D1/CCD1 Response Form

Street Name West 131st Street

Job No. 121185760

CONTROL #42151

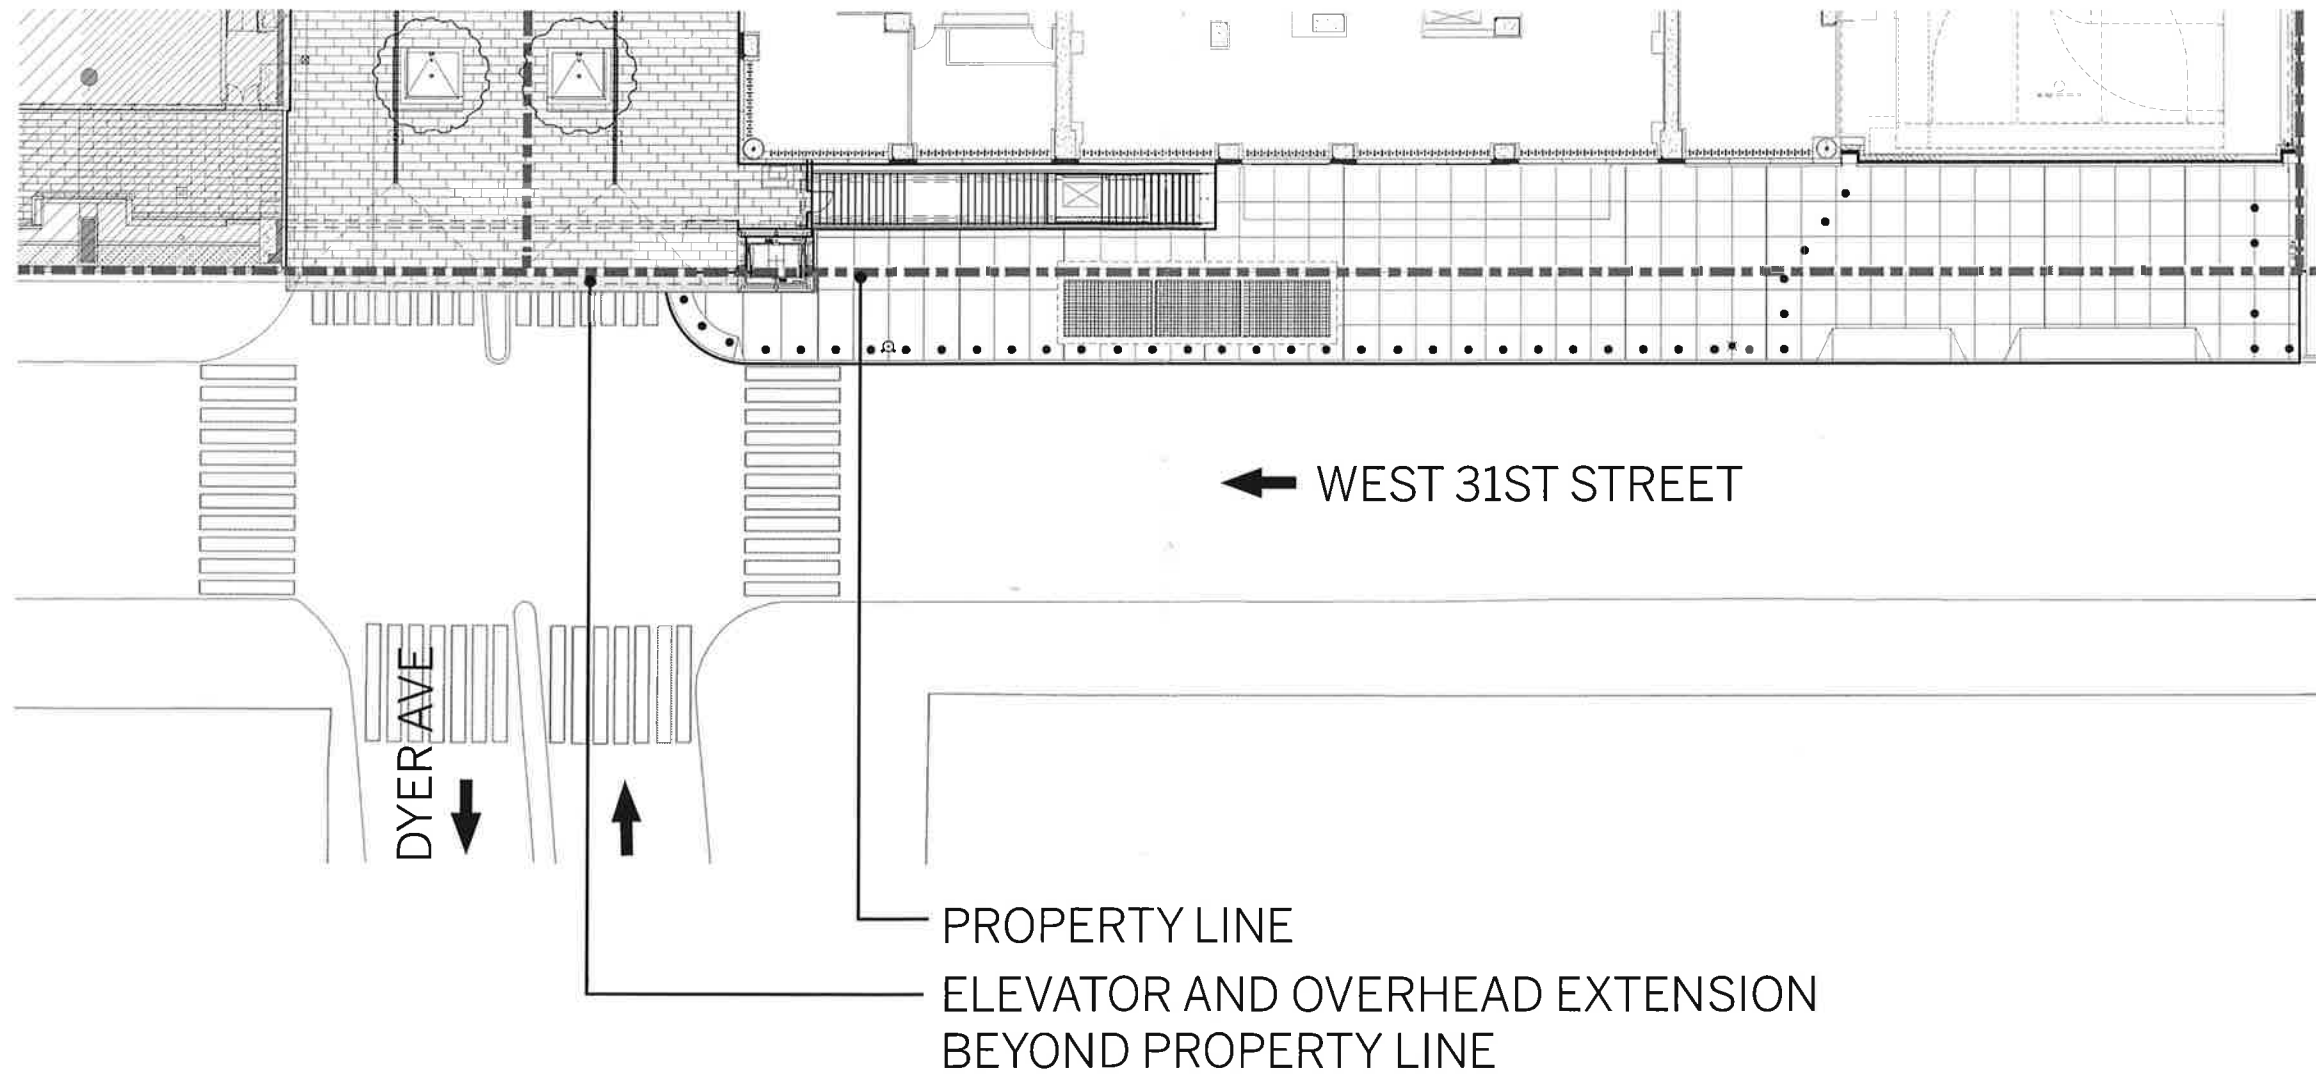
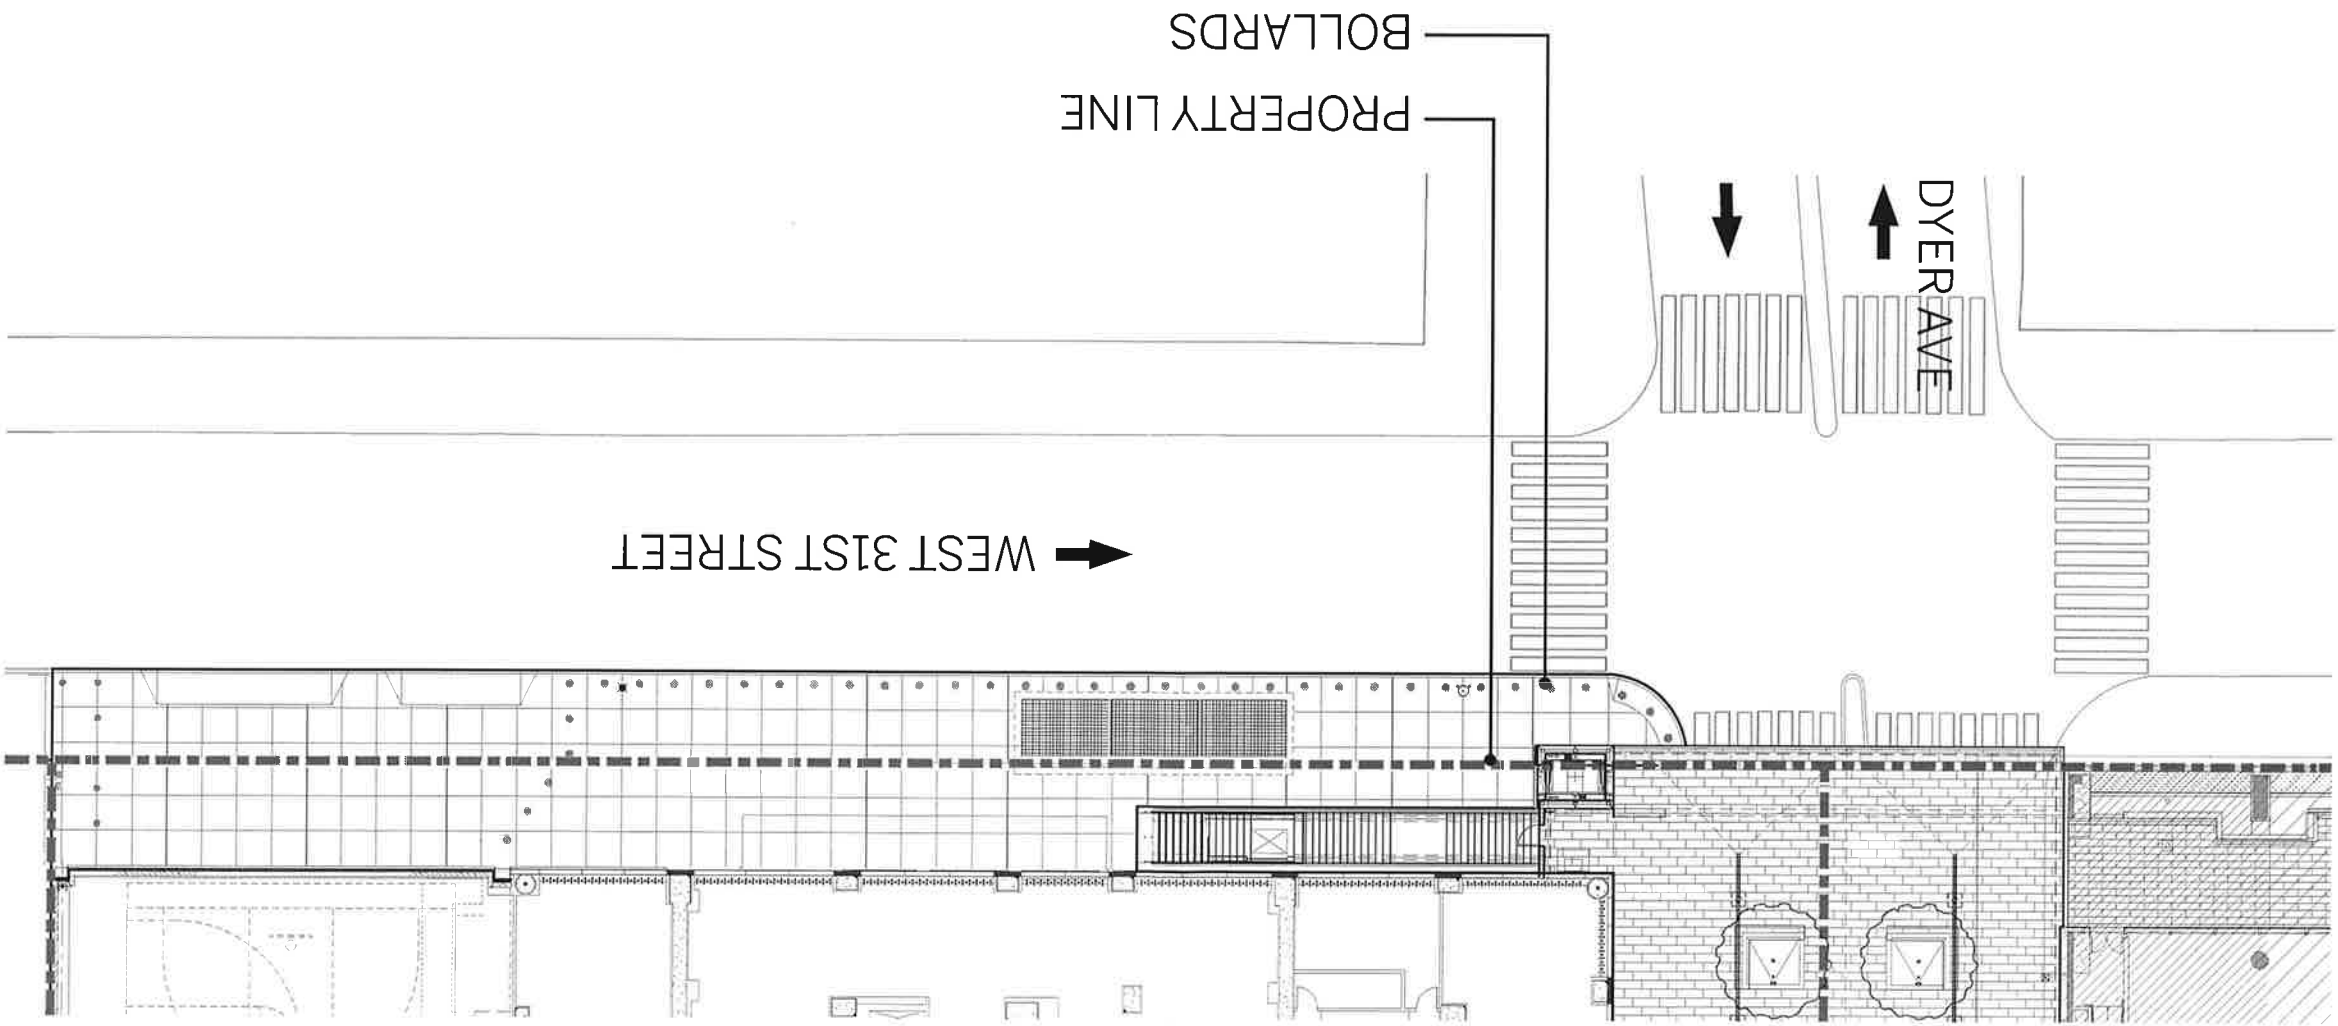
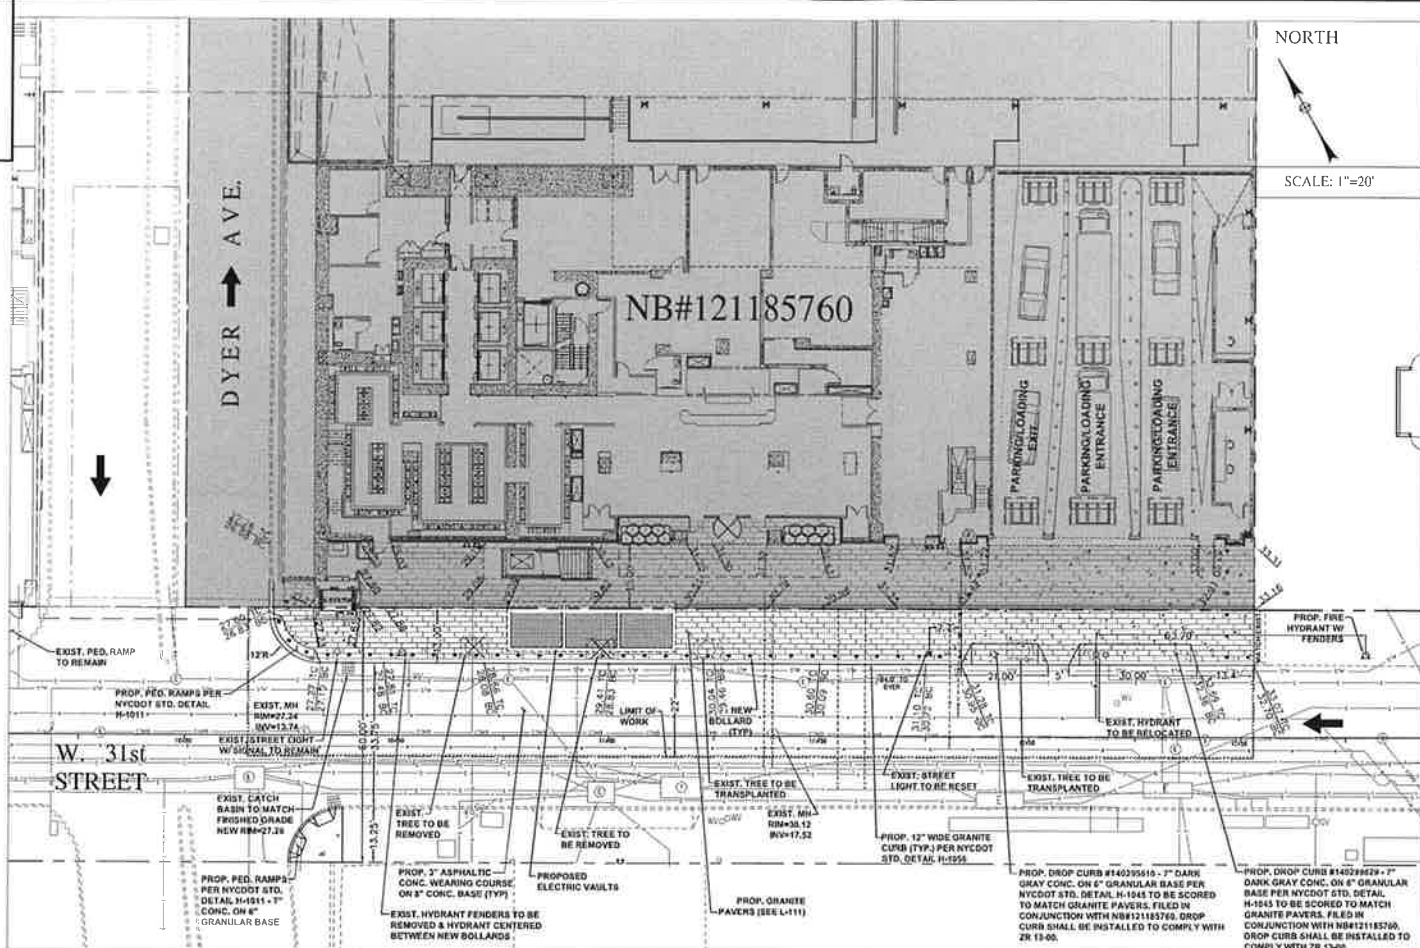
Determination is requested regarding the proposed proposed construction at the site that will project past the property line. Per the attached plans a portion of the elevator which provides handicap access to the Dyer Ave overbuild and the entire Manhattan west public plaza, a portion of the Dyer ave overbuild and the proposed bollards will all project past the property line as shown.

The proposed projections have been filed with DOT to obtain revocable consent approval and the process is currently moving forward with DOT.

At this time DOT has requested that the DOB review and approved the proposed projections as part of the NB application (121185760) in question prior to the finalization of the revocable consent approval. CCD1 is being submitted to allow the plan examiner for the new building to proceed with approving the revised NB plans showing the projects past the property line. Ed Schnell from DOT had previously discussed this issue with Commissioner Rebholz and notified him that DOB approval of the projections past the property line is required prior to DOT being able to finalize the revocable consent approval

Based on the above and the attached we are requesting written acceptance to be able to pproceed with approval of revised drawings showing the proposed projects past the property line as part of NB application 121185760.

NYC DOT has requested that the department provide an authorization to allow an alternate protocol for the order of approval between DOT and DOB for a proposed encroachment into the public sidewalk by a passenger elevator and unroofed stair for allowing access between sidewalk level and a proposed raised private courtyard.

Upon review and consideration, the department agrees: although the encroachment of 36" is greater than 18", DOB does not require that a Revocable Consent first be in place to provide final approval of the elevator project as part of an amended DOB application by the Petitioner, for this specific condition for this specific project.
